NOTICE OF DECISION FRANKLIN DUPLEX NORTH FILE NO. CUP17-01

FINAL ORDER

CUP17-01 (Franklin Duplex North)

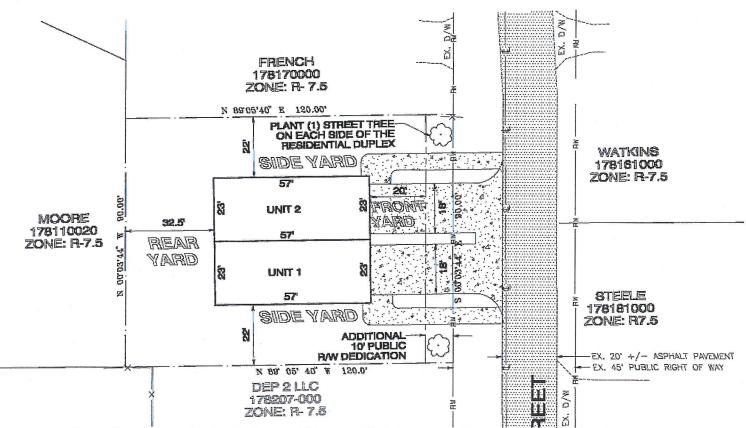
Note: Site plan as depicted above will be modified as required by conditions in this decision.

- 10. The applicant shall revise the site plan drawings to illustrate the location of the minimum setback standards per CMC18.09.040 Table 2, and to include the front setback exception standard for sloping lots per CMC18.09.130. The front structure setback is 18-feet, the side setback is 5-feet and the rear setback is 25-feet. The maximum lot coverage is 40%.

- 11. The design of the duplex will be revised to adjust the amount of garage frontage to be no greater than 50% of the total lineal feet of the front building face. The entrance of the residence will be either forward of the front face of the garage or flush with the garage and distinguished with architectural elements (e.g. covered porch, pillars).
